# HISTORIC SITE PRESERVATION BOARD STAFF REPORT

July 8, 2014

A CERTIFICATE OF APPROVAL REQUEST BY BRENT SMITH, OWNER, PROPOSING THREE NEW WINDOWS AND A SKYLIGHT IN UNIT #120, A CONTRIBUTING STRUCTURE SUBJECT TO CLASS 1 REGULATIONS WITHIN THE RACQUET CLUB COTTAGES WEST HISTORIC DISTRICT (HSPB 88 / HD-3) LOCATED AT 360 CABRILLO ROAD (UNIT #120), (ZONE: RGA-6) AND A CATEGORICAL

TYPICAL ENTRY SHOWING LOCATION OF PROPOSED BEDROOM WINDOW

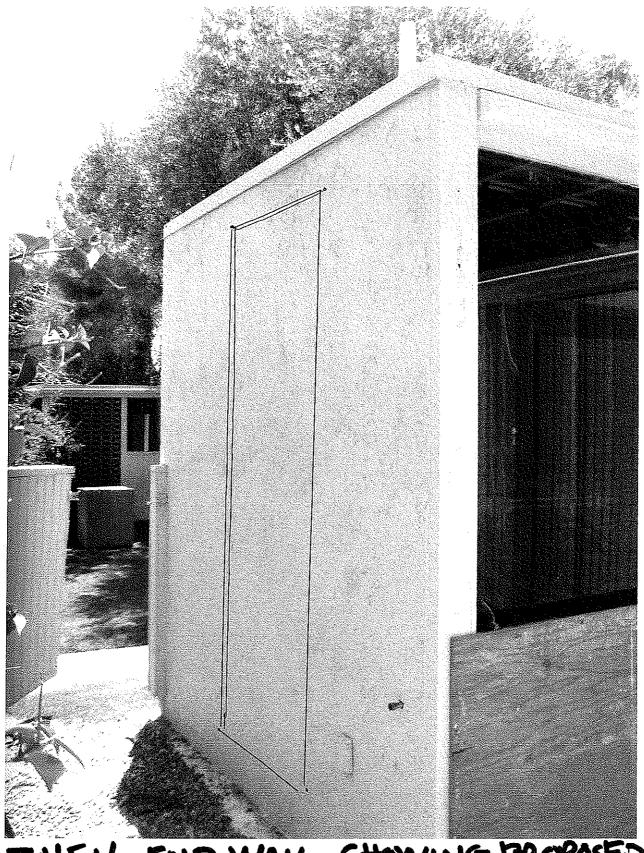
The owner of unit 120 proposes to reconfigure two dressing rooms into a bedroom. This requires adding two operable windows adjacent to the entry doors into the unit to comply with the California Building Code for natural light, ventilation and egress from a sleeping room. Roughly one third of the units in RCCW have converted the dressing rooms to bedrooms and installed windows in the same location and size as the applicant is proposing.

The proposed windows are adjacent to the exterior entry doors. The framing and trim around the windows as well as the manner in which the window is set into the existing wall are proposed to be detailed in the same manner as the original windows designed

by Cody that are adjacent to the doors. Original operable windows in the complex are metal sash and set slightly recessed into the wall, and the proposed windows are proposed in the same manner. A unique detail at the head (top) and sill of the original windows in the complex will also be carried forward into the proposed new bedroom windows. The windows will be roughly twenty-four (24) inches in width and match original adjacent windows in height as closely as possible.

KITCHEN END WALL SHOWING PROPOSED SIZE & LOCATION OF WINDOW

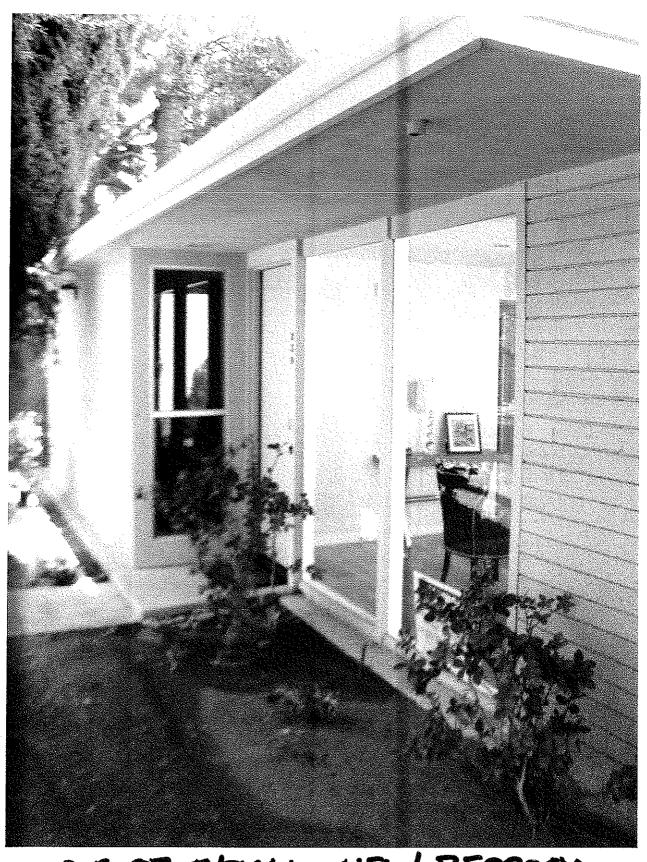
The applicant is also proposing a new window in the end wall of the kitchen. This window is proposed to match in detailing to the original windows found in the bathrooms at RCCW, except this will be clear glass whereas the bathroom windows are translucent. This window is also proposed to be twenty-four inches in width and matching in height to that of existing windows in the complex. The detailing at the existing bathroom windows is slightly different from those adjacent to the front doors. They are flush with the face of the stucco walls, and the new window proposed in the kitchen is detailed in the same manner. The kitchen window is located behind one of the existing original decorative concrete block screen walls.

EXISTING (ORIGINAL) TYPICAL BATHROOM WINDOW (NOTE WINDOW IS FUSH WITCH OF STUCLO, NOT RECESSED)

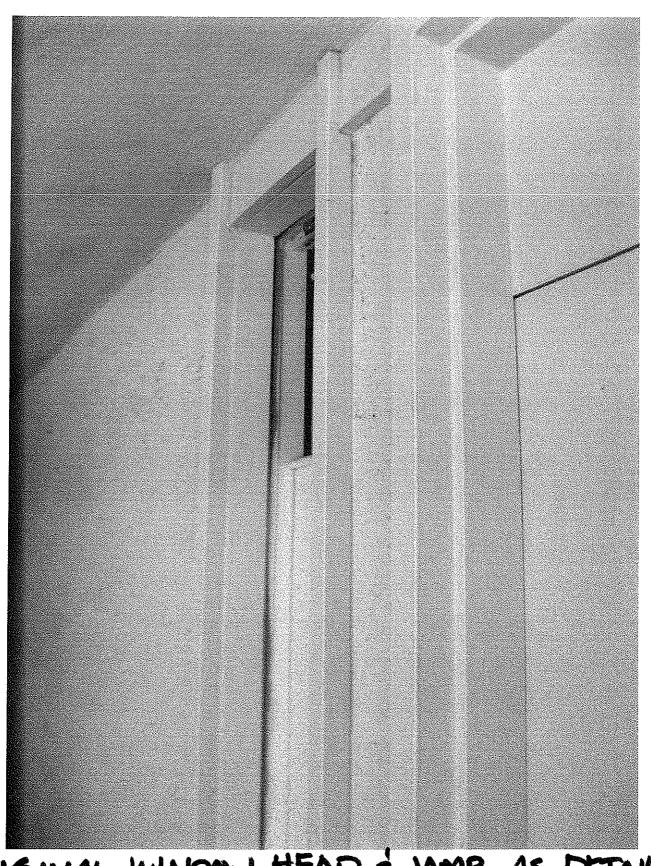
The proposed windows are detailed to convey the same appearance of adjacent original windows. The kitchen window is detailed similarly to original windows in the bathrooms
